Remove and discard wing lock linkage and wing lock pin from both sides of the machine

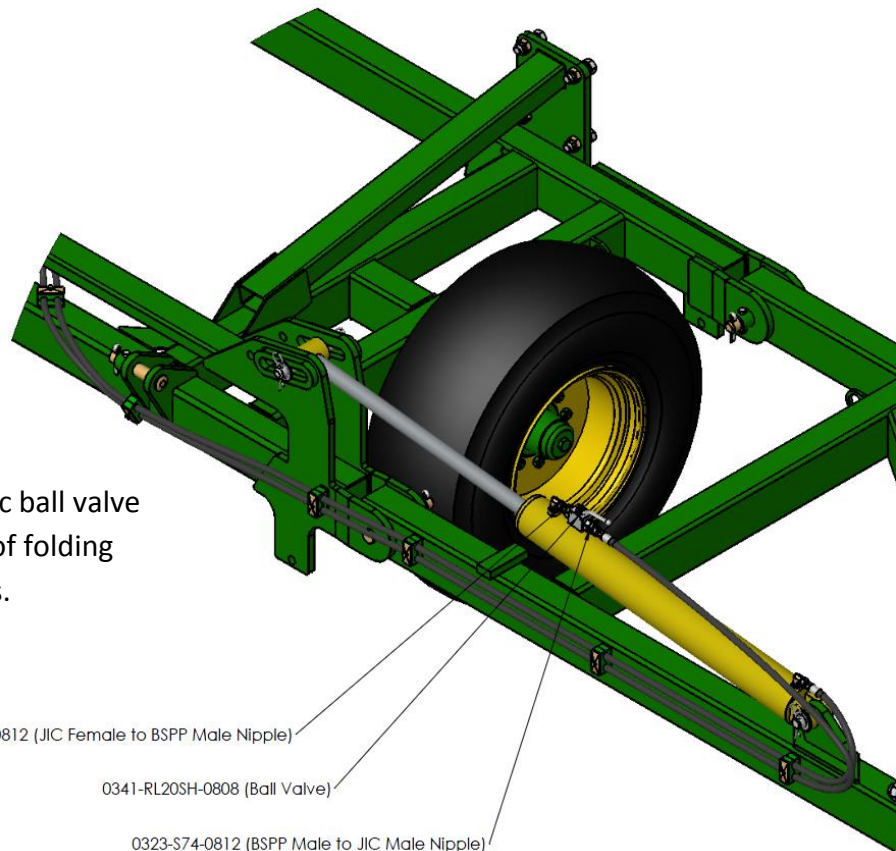
Replace with hydraulic ball valve attached to rod port of folding cylinder on both sides.

0323-S71-0812 (JIC Female to BSPP Male Nipple)

0341-RL20SH-0808 (Ball Valve)

0323-S74-0812 (BSPP Male to JIC Male Nipple)
